PROPOSED TECHNICAL SPECIFICATION CHANGE

SEQUOYAH NUCLEAR PLANT UNITS 1 AND 2

(TVA-SQN-TS-89-26)

Description of Change

Figure 15.4.2-2 Transient Response to Steam Line Break Downstream of Flow Measuring Nozzle with Safety Injection and Off-Site Power (case a)

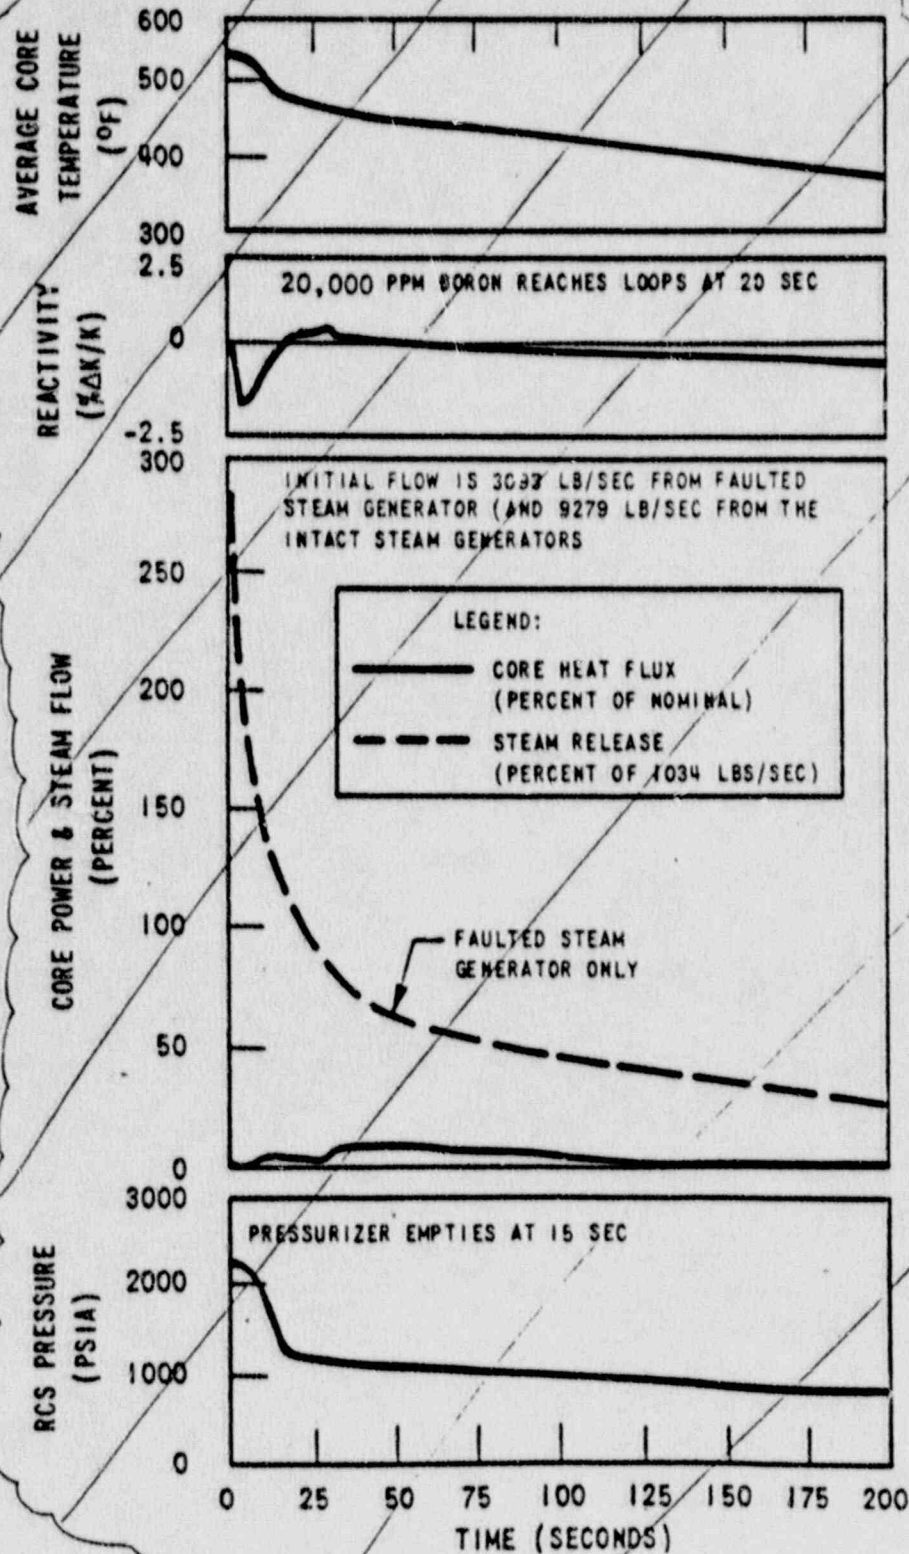
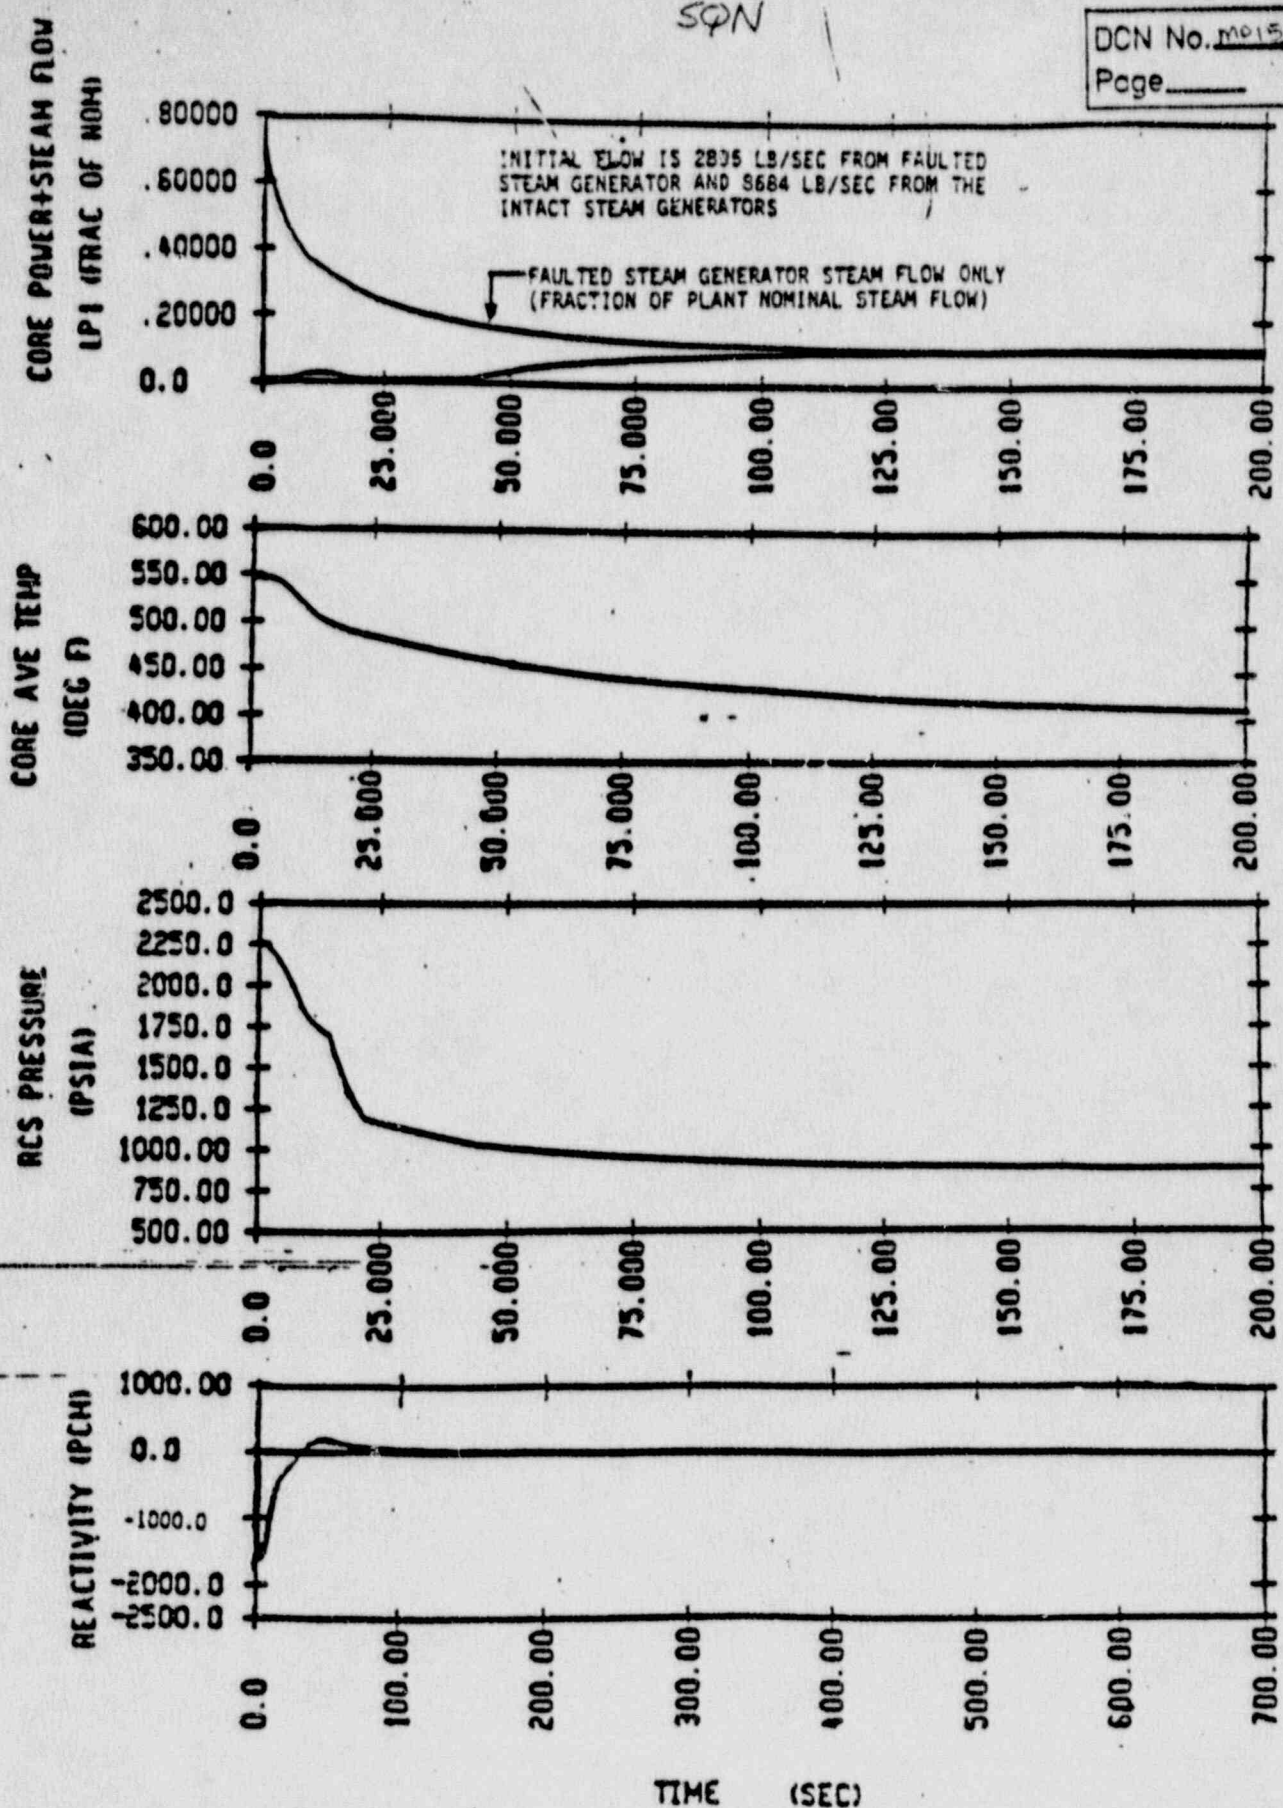
As shown in Figure 15.4.2-2 the core attains criticality with the rod cluster control assemblies inserted (with the design shutdown assuming one stuck assembly) before boron solution of approximately 20,000 ppm enters the RCS from the Safety Injection System. The delay time consists of the time to receive and actuate the safety injection signal and the time to completely open valve trains in the safety injection lines. The safety injection pumps are then ready to deliver flow. At this stage a further delay time is incurred before boron solution can be injected to the RCS due to low concentration solution being swept from the safety injection lines. A peak core power well below the nominal full power value is attained.

Delete and Replace

Figure 15.4.2-3 Transient Response to Steam Line Break at Exit of Steam Generator with Safety Injection and Off-Site Power (case b)

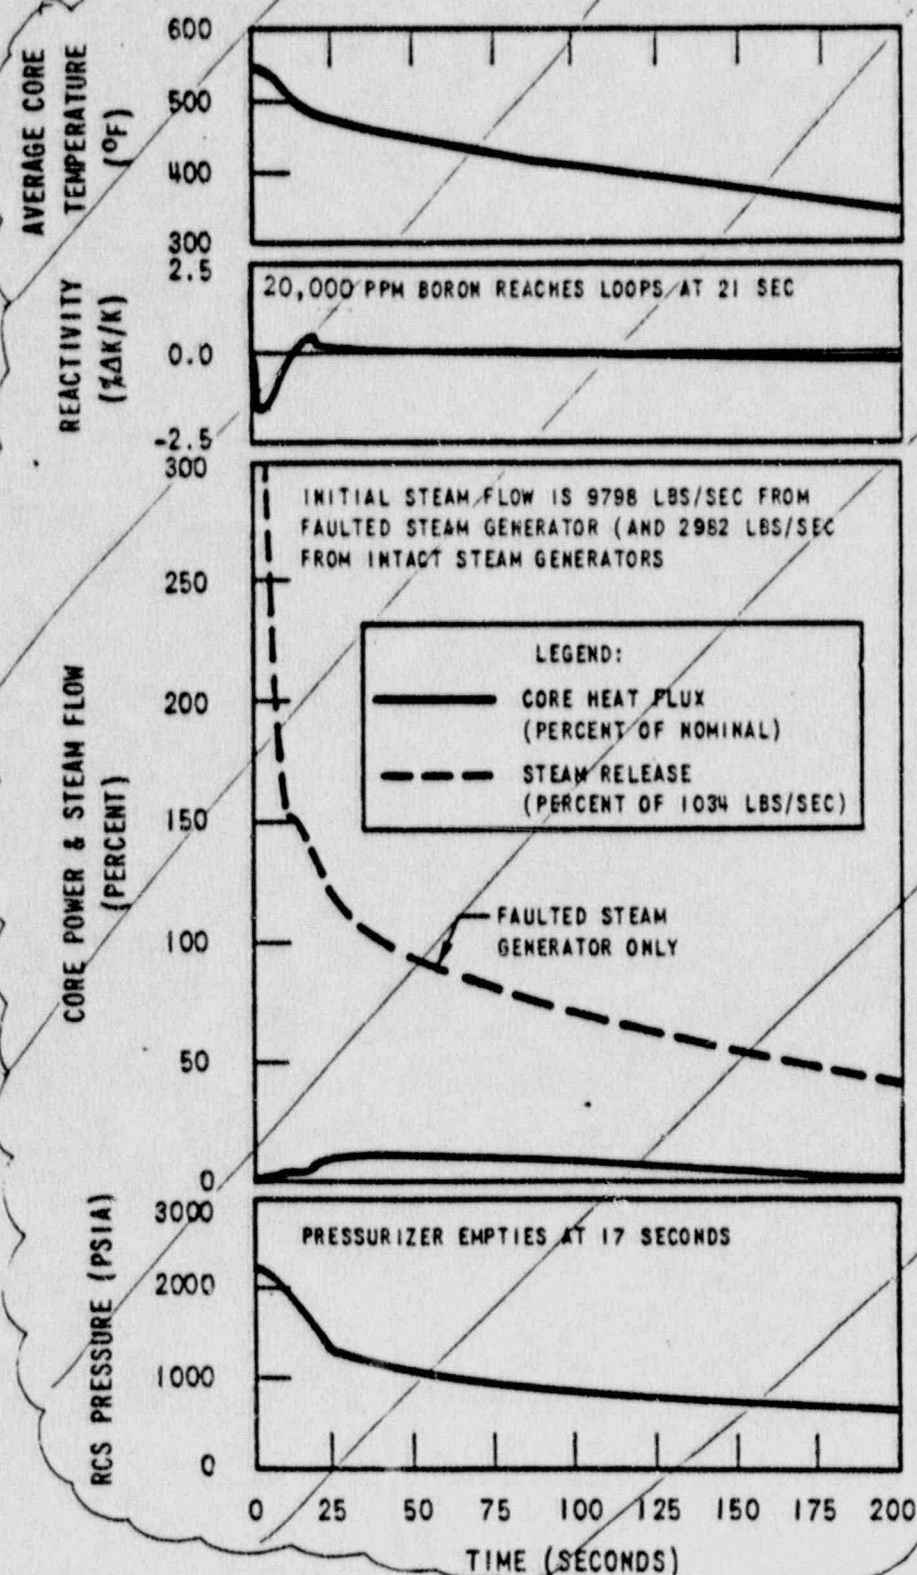
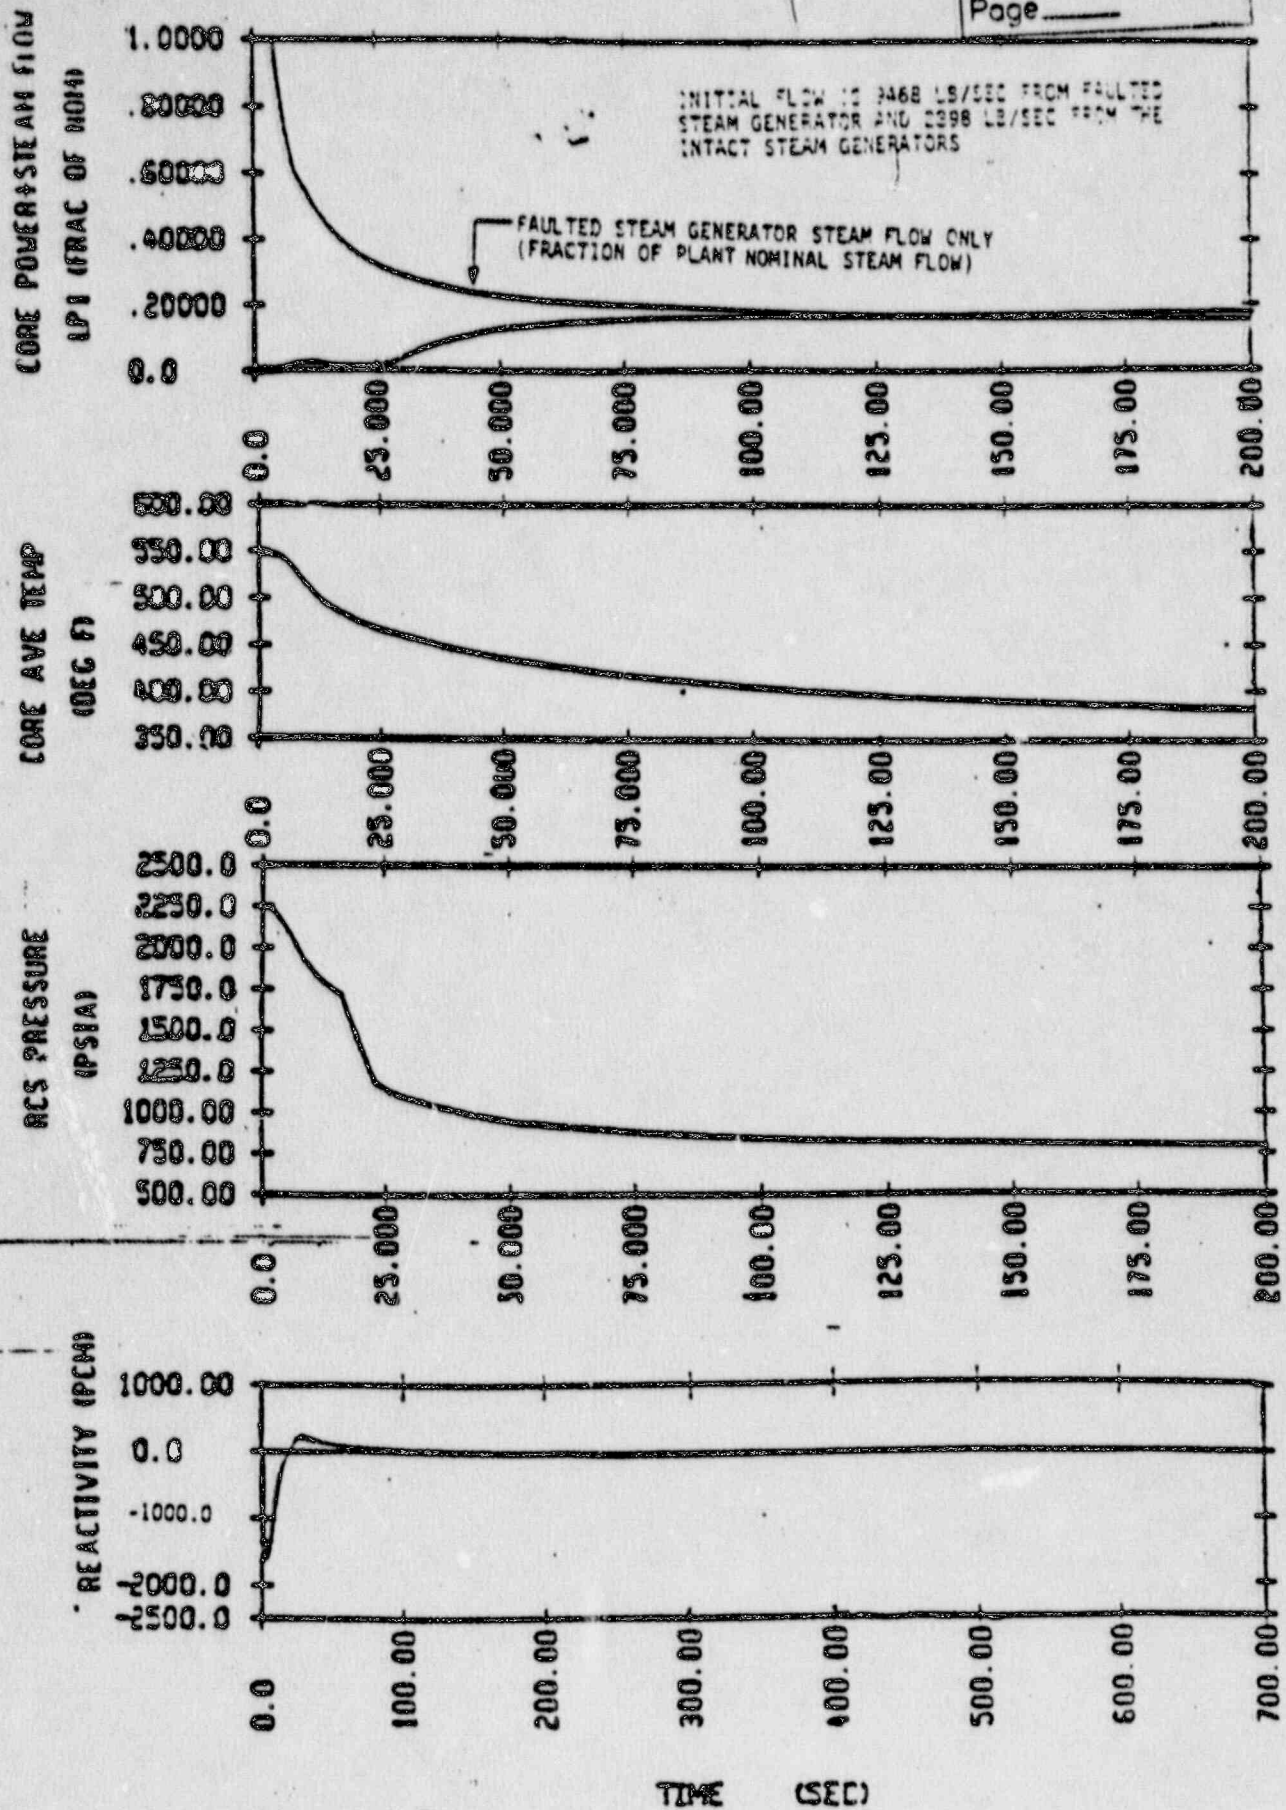
Figure 15.4.2-3 shows Case B, a steam line rupture at the exit of a steam generator (upstream of the flow measuring nozzles) at no load. The sequence of events is similar to that described above for the rupture outside the containment except that criticality is attained earlier due to more rapid cooldown and a higher peak core average power is attained.

Delete and Replace
